Docket No. 50-271 BVY 99-75

Vermont Yankee Nuclear Power Station Proposed Technical Specifics on Change No. 203 Suppression Pool Water Temperature Surveillance Marked-up Version of the Current Technical Specifications

Proposed Technical Specification Change No. 203

Suppression Pool Water Temperature Surveillance

- 4.7 SURVEILLANCE REQUIREMENTS
- 4.7 STATION CONTAINMENT SYSTEMS

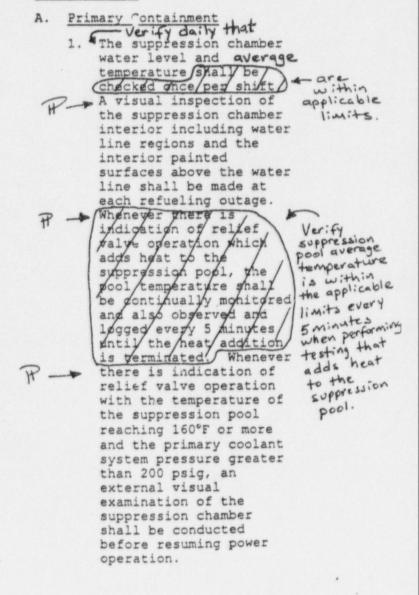
Move next to page

The water in the suppression chamber is used only for cooling in the event of an accident, i.e., it is not used for normal operation; therefore, a weekly check of the temperature and volume is adequate to assure that adequate heat pemoval capability is present.

- A. Primary Containment
  - Verify daily that the suppression chamber water level and average temperature are within applicable limits.

Verify suppression pool average temperature is within the applicable limits every 5 minutes when performing testing that adds heat to the suppression pool.
